Work Order ID 58271

Item Name: Side Door Assembly RH

DART AEROSPACE LTD HAWKESBURY, ONTARIO, CANADA	
DRAWING NO. D2991	REV. D SHEET 1 OF 5
TITLE SIDE DOOR	SCALE NTS
COPYRIGHT © 2002 BY DART AEROSPACE LTD THIS DOCUMENT IS PRIVATE AND CONFIDENTIAL AND IS SUPPLIED ON THE EXPRESS CONDITION THAT IT IS NOT TO BE USED FOR ANY PURPOSE OR COPIED OR COMMUNICATED TO ANY OTHER PERSON WITHOUT WRITTEN PERMISSION FROM DART AEROSPACE LTD.

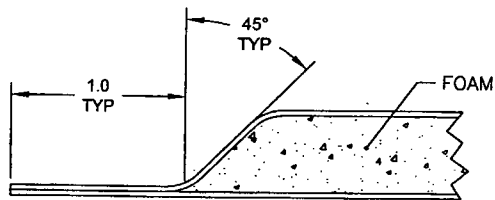
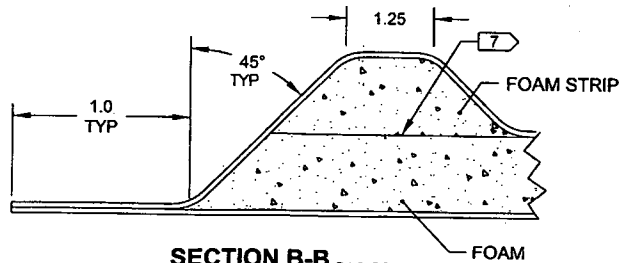
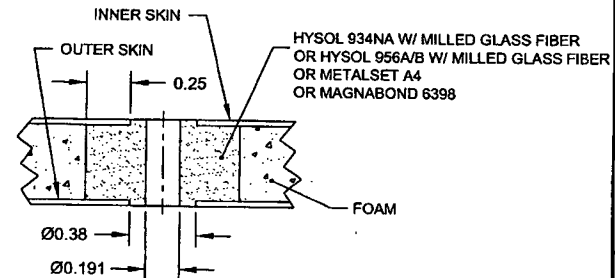
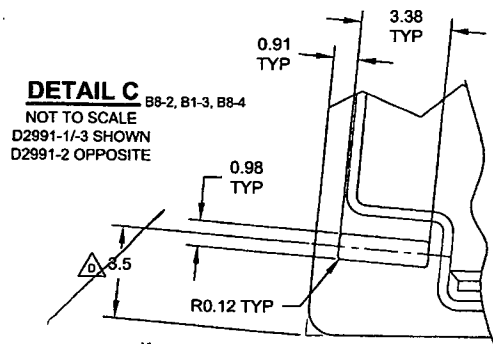
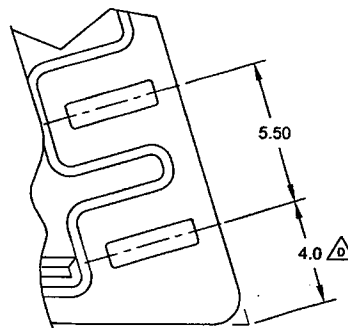
2.5"
P10.06.03

W/O: 58271		WORK ORDER CHANGES						
DATE	STEP	PROCEDURE CHANGE	By	Date	Qty	Approval Chief Eng / Prod Mgr	Approval QC Inspector	
10.06.08	140	DRILL AFT LATCH 2.5" FROM BOTTOM INSTEAD OF 3.5"	RT	10-06-10	1	 10.06.08 DSI 042	 100610	
10-06-10	140	upon installation of 02586 Door latch, it was found that there wasn't enough clearance for the head of the screw MS27039-1-15 to allow the latch to close properly + allow sufficient thread showing on nut side of screw. Door latch was originally machined properly + within tolerance as per B57917. Remove just enough material to allow proper function	RT	10-06-10	1	 DSI 042	 10-06-10
